STATE OF NORTH CAROLINA
DEPARTMENT OF TRANSPORTATION
DIVISION OF HIGHWAYS

TIP NUMBER: B-4237
WBS ELEMENT: 33580.3.1

DESCRIPTION: Replacement of Bridge #25 over Fork Swamp in Pitt County
ADDENDUM NUMBER 1

PROJECT REFERENCE NO.	SHEET NO.
B-4237	UC3
UTILITY DESIGN ENGINEER	UTILITY DESIGN ENGINEER

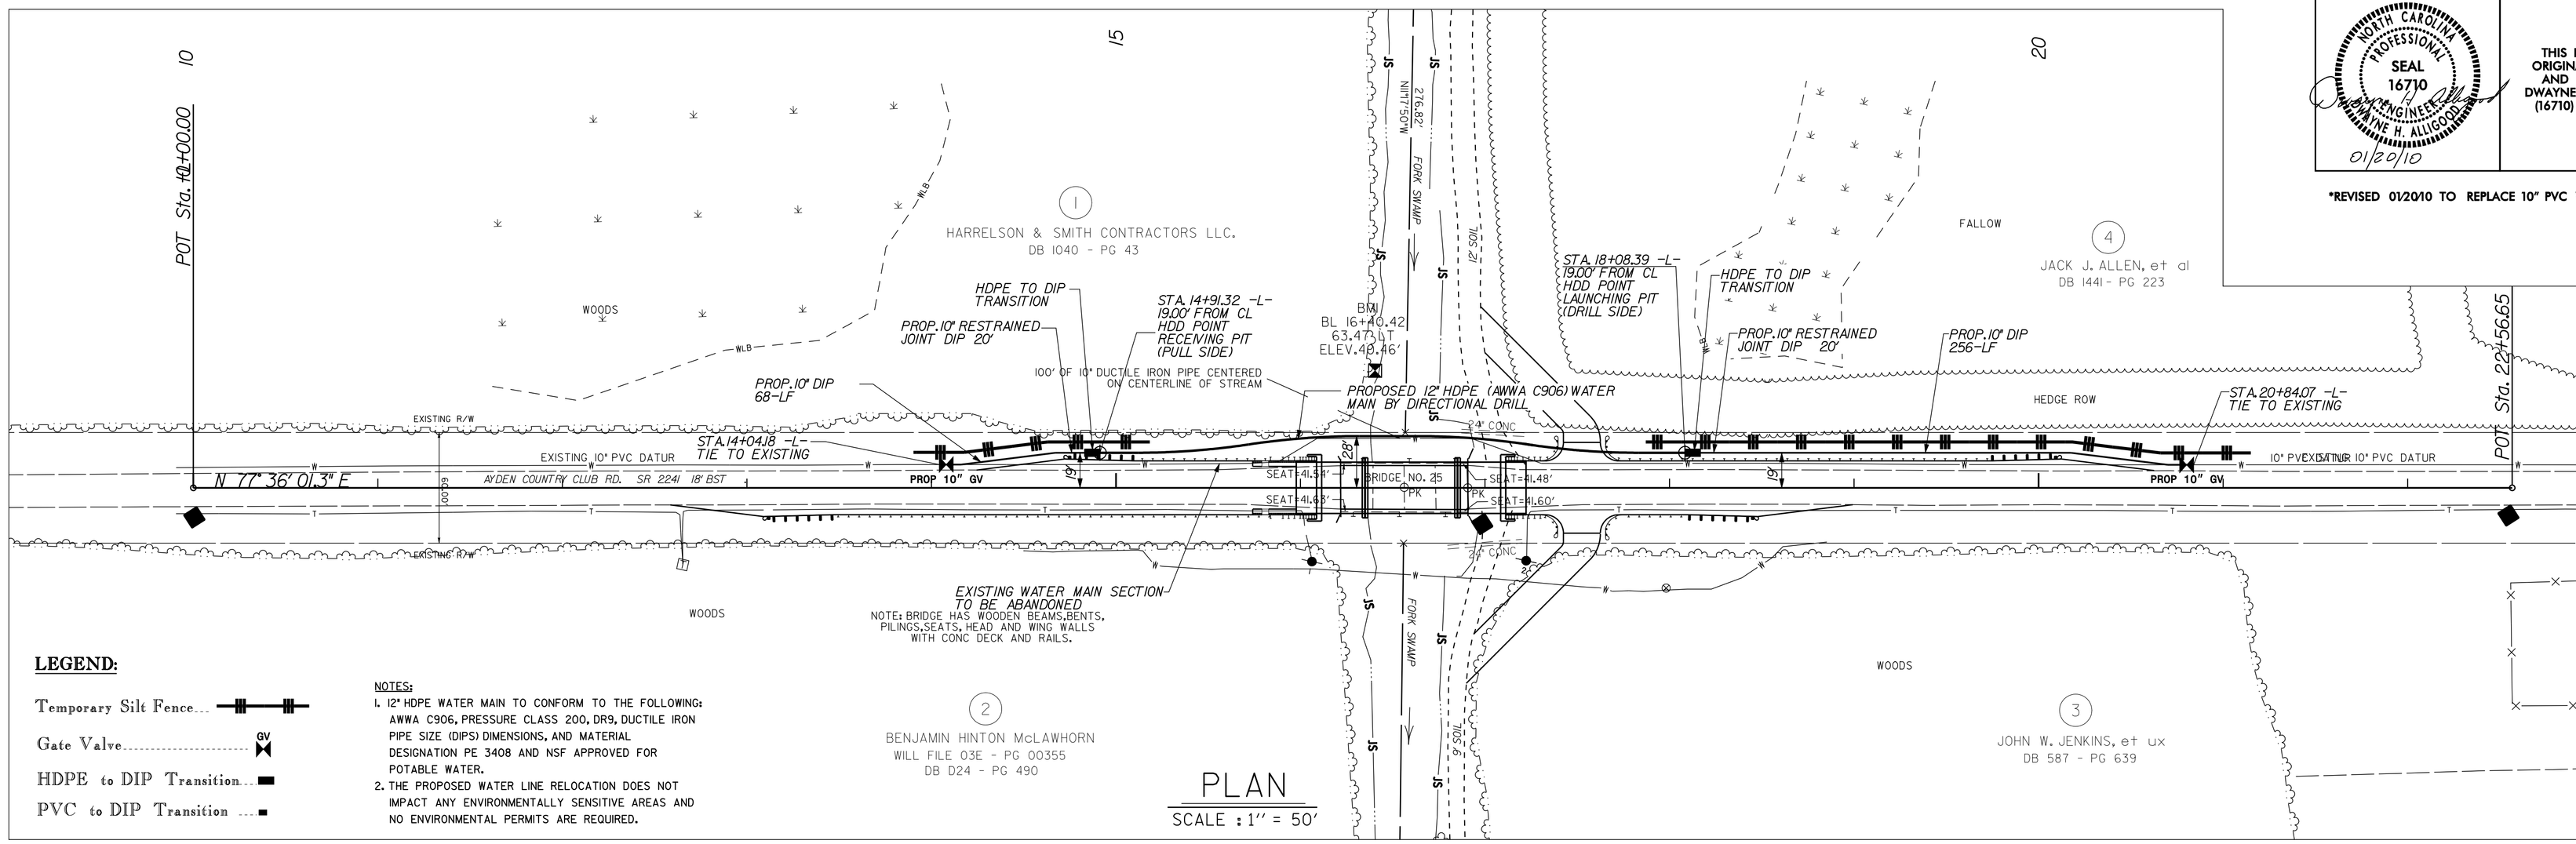
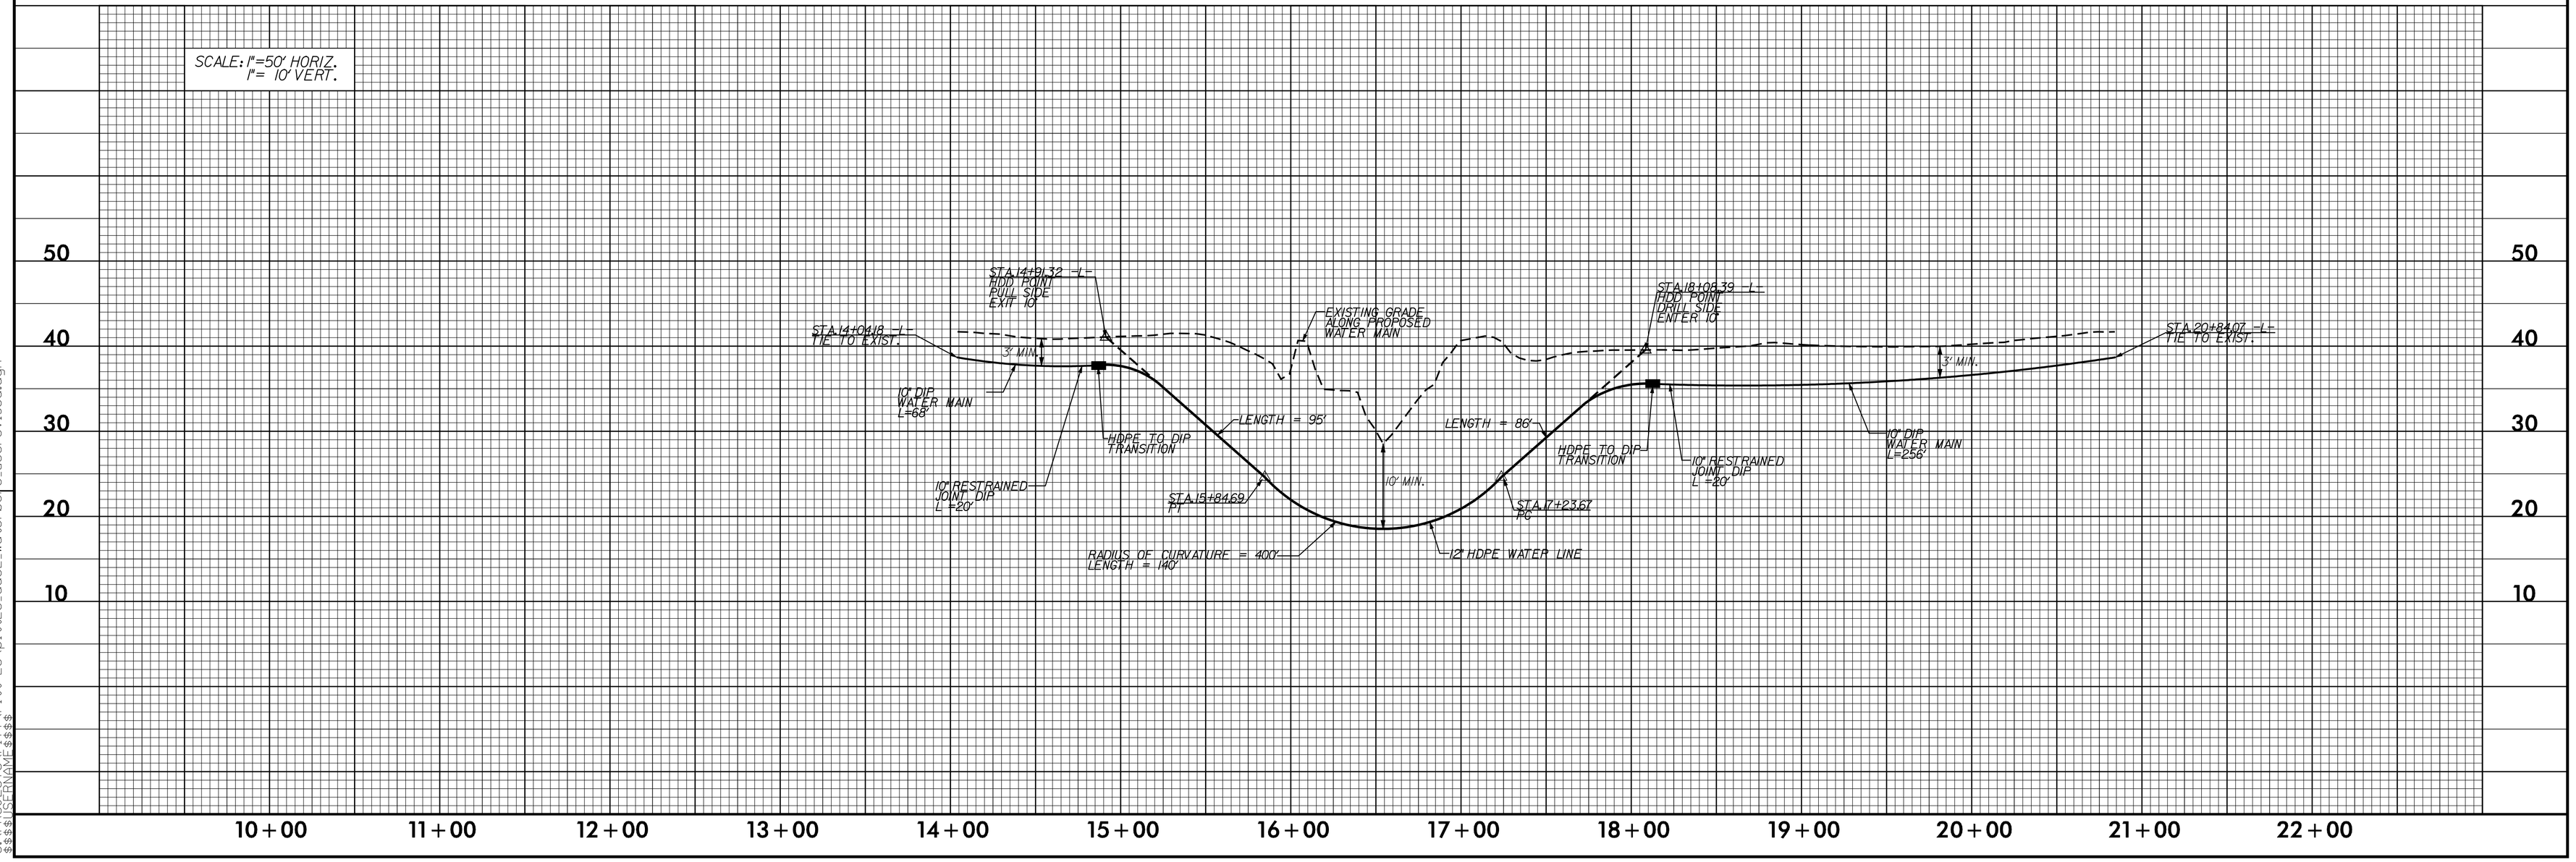
- Replace plan sheets UC2 and UC3 with the attached sheets, denoting a change to ductile iron pipe.

*REVISED 01/20/10 TO REPLACE 10" PVC WITH 10" DIP.

*REVISED 01/20/10 TO REPLACE 10" PVC WITH 10" DIP.
